Notice of Meeting
Polk City | Planning and Zoning Commission (P&Z)

P.U.D. MASTER PLAN

Date: March 13, 2019
Project: Bridgeview Plat 2

Memorandum

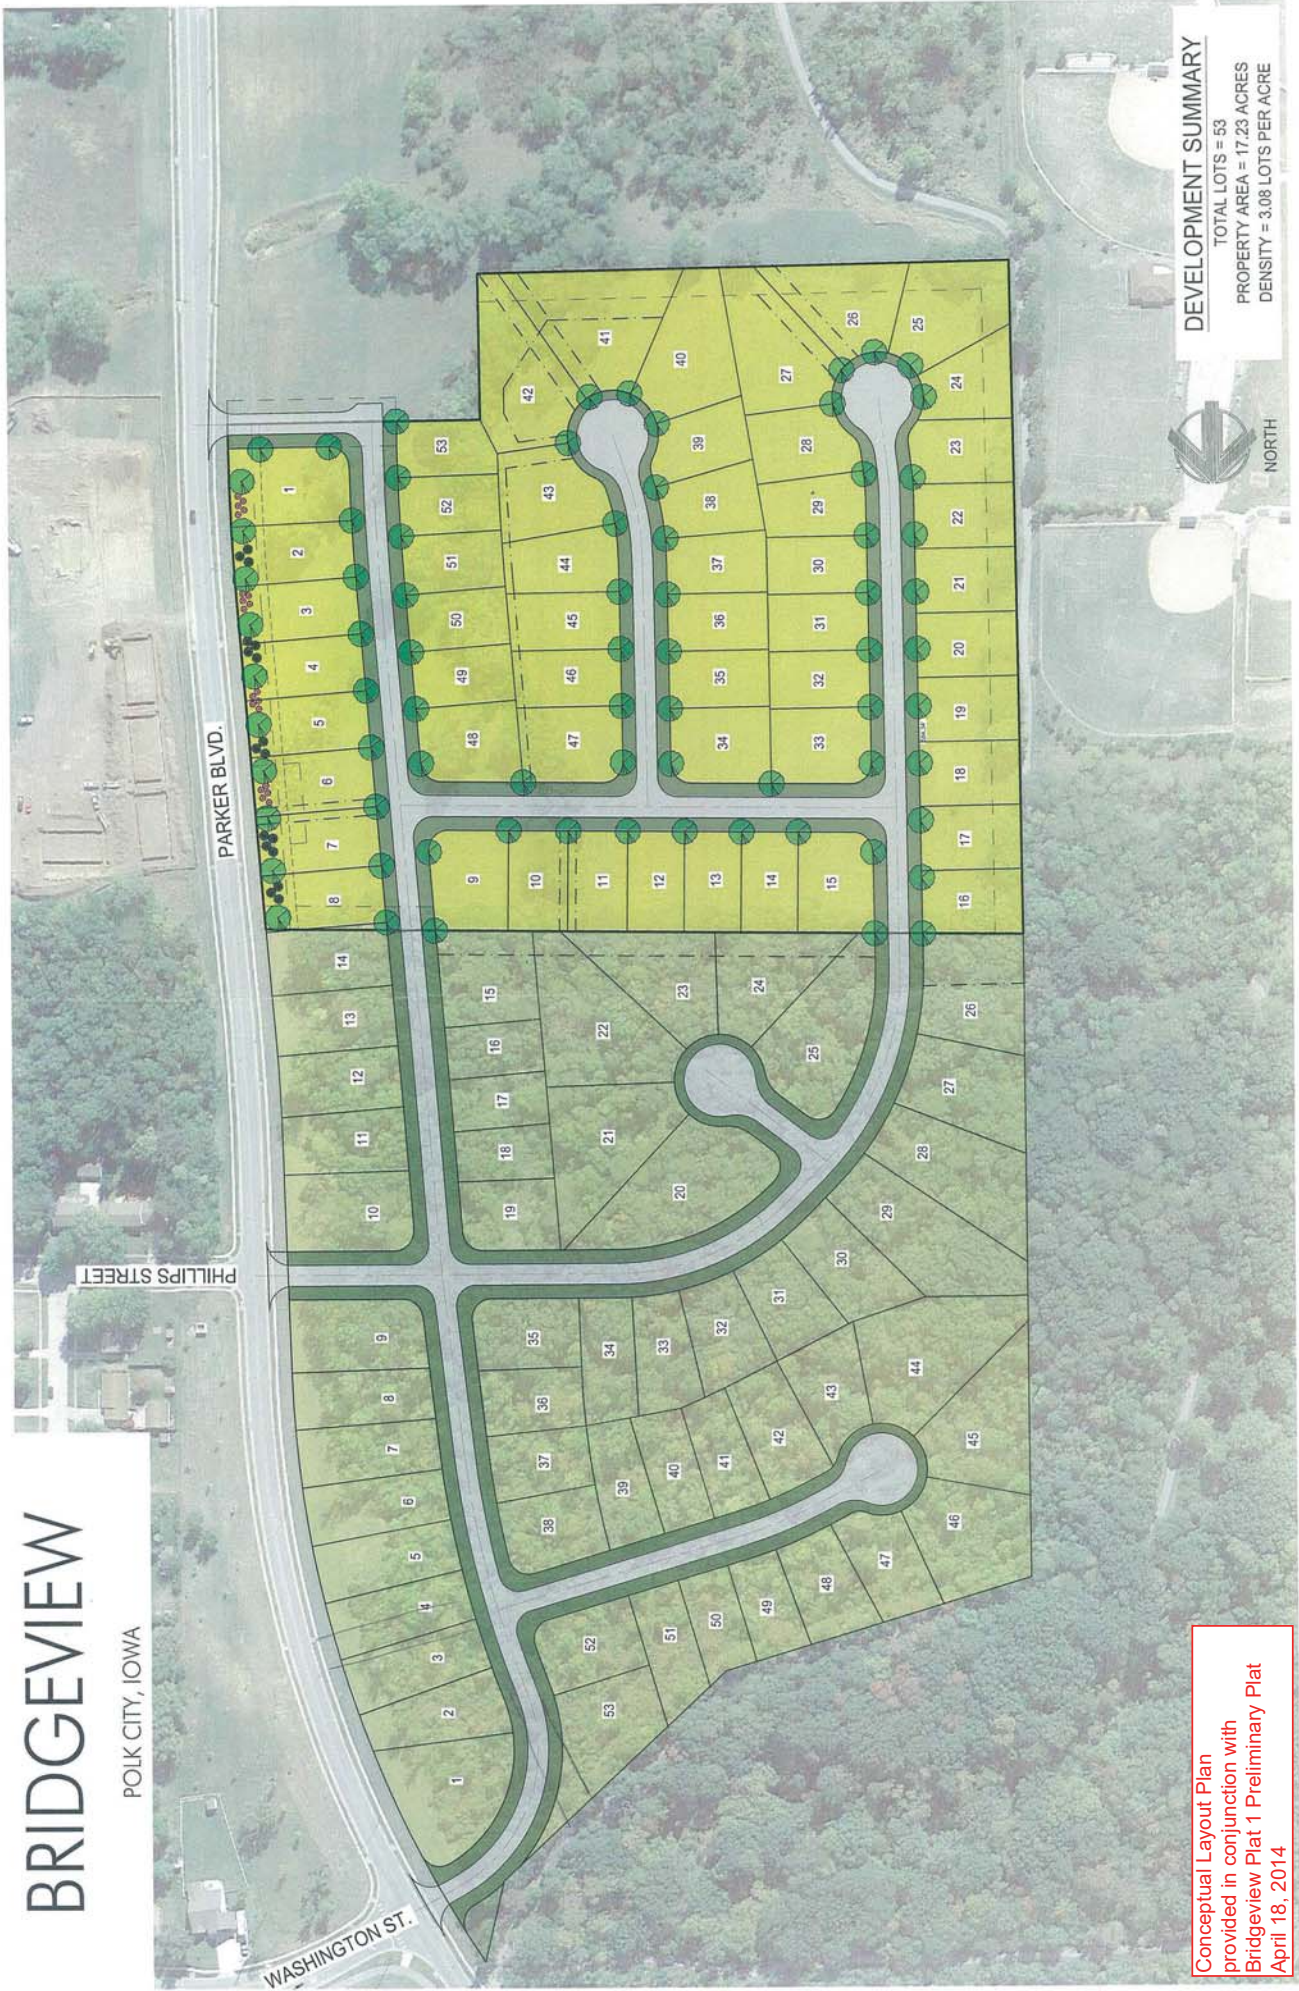
A P.U.D. Master Plan was presented to P&Z at their January 21st meeting, but the motion for approval failed to pass. Concerns expressed by the Commission include concern regarding the location of the Pelican Drive and Parker Blvd. intersection and that the train connection ended at the sidewalk instead of the street. The Commission also encouraged the developer to talk to the neighbors regarding a buffer along the south side of the development.

The developer agreed to relocate the storm sewer to the south side of Lot 35, rather than running along the south property line, in order to save trees. After meeting with the neighbors, the developer is now willing to plat the south fifty feet, between Bridgeview Street and Pelican Drive, into seven outlots. We understand the property owners have agreed to purchase these outlots from the developer. These outlots will individually be tied to the adjoining lot at the time of final platting.

Justin Jackson, Polk City's traffic engineer, has reviewed the proposed location of the Pelican Drive/Parker Boulevard intersection. Per the attached Memo, the proposed intersection meets access spacing requirements per SUDAS. The trail connection has been revised per P&Z direction.

The distance along Parker Boulevard, between Pelican Drive and Edgewater Drive (in Bridgeview Plat 1) is approximately 1,480 feet. This exceeds the maximum block length of 1,300 feet per the Subdivision Regulations, however this requirement can be modified by a P.U.D. Master Plan. Given the potential for saving trees by eliminating the Phillips Street connection and since the additional block length is relatively minor, staff believes this a reasonable trade-off.

A detention basin will be located on Lot 18 to control runoff velocity and mitigate erosion. Tree removal should be kept to a minimum for these facilities.

Building setbacks for rear yards will be increased to exclude areas outside coverage radii as buildable for principal structure, per Polk City Fire Code.

Pursuant to our review of the revised P.U.D. Master Plan received 3/12/19, we believe P&Z's concerns and staff's review comments have been addressed.

Parker Boulevard Intersection Spacing

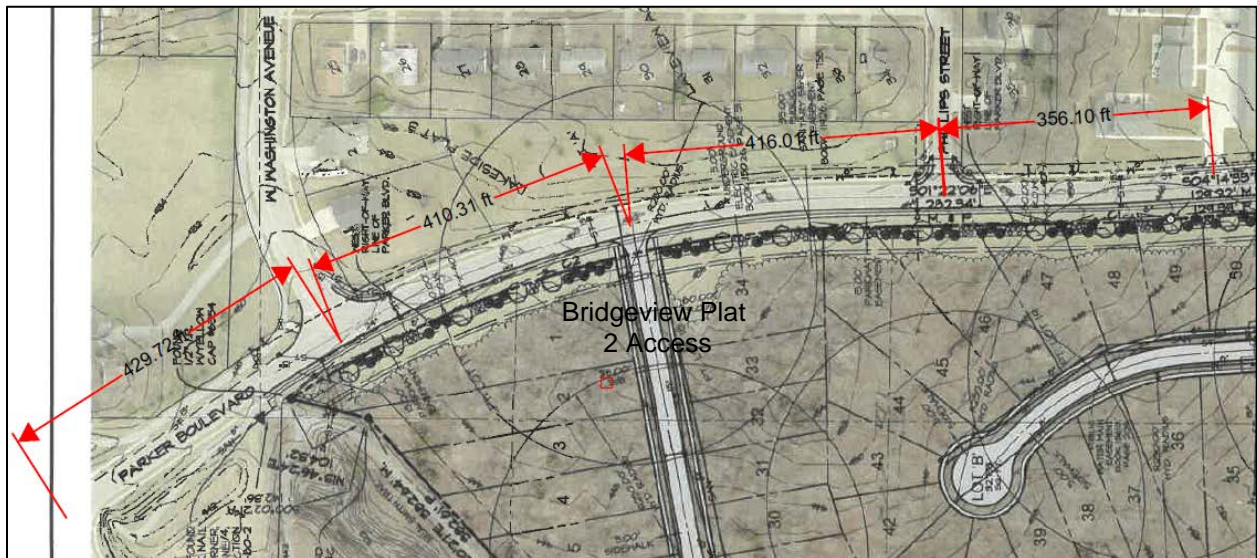
Civil Engineering Consultants, Inc. submitted the Bridgeview Plat 2 master plan on January 16, 2019. The master plan was reviewed for the development’s access onto Parker Boulevard in regards to location and spacing from existing street connections onto Parker Boulevard. The 2019 Iowa Statewide Urban Design and Specifications (SUDAS) was used as reference guidance for compliance of intersection spacing. Chapter 5C-2 of SUDAS provides intersection alignment and spacing guidance as shown below.

2. Intersection Alignment: The centerline of a street approaching another street from the opposite side should not be offset. If the offset cannot be avoided, the offset should be 150 feet or greater for local streets. The centerline of a local street approaching an arterial or collector street from opposite side should not be offset unless such offset is 300 feet or greater.

The figure below shows the distances between existing local streets and the Bridgeview’s proposed access along Parker Boulevard. The spacing of the proposed access into Bridgeview Plat 2 has sufficient distance to adjacent existing intersections. The proposed location of the Bridgeview Plat 2 access should not have any significant negative impact to traffic flow along Parker Boulevard based on projected development traffic volume generation.
